Service Bulletin

Model : GP405/335

No.: GP405-011
(FF-T01-J7-000030-01)

Subject : INSTALLING MULTI-OUTPUT TRAY-D1

Location : MAIN UNIT LEFT SIDE PANEL

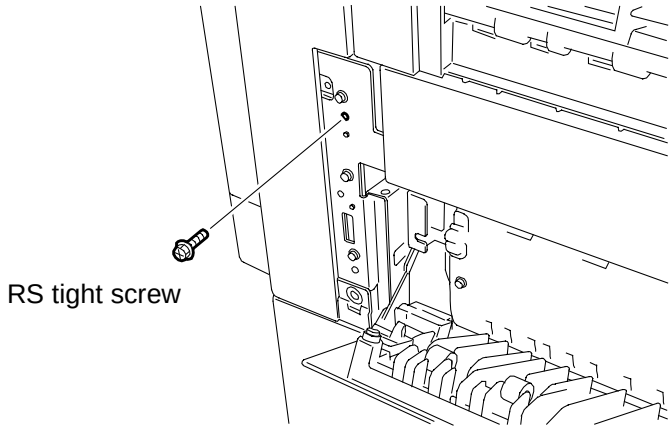
Reason : Upon shipment from the factory, some of the MULTI-OUTPUT TRAY-D1 fixing screws have untapped holes. This is to describe the field fix and countermeasure.

Details : < FIELD FIX >
When mounting the MULTI-OUTPUT TRAY-D1, the hinge (FB4-3791-000: Parts calatogue FY8-31CK-020 Q10-3) is attached to the copier main unit, but due to a mistake during assembly, some were shipped out with screws that have untapped holes. The field fix is as follows:

Remove the RS tight screw that secures the Front Left Cover (FB4-3233) and use it to tap the screw hole in the location shown in the diagram below.

Then, mount the MULTI-OUTPUT TRAY-D1 hinge.
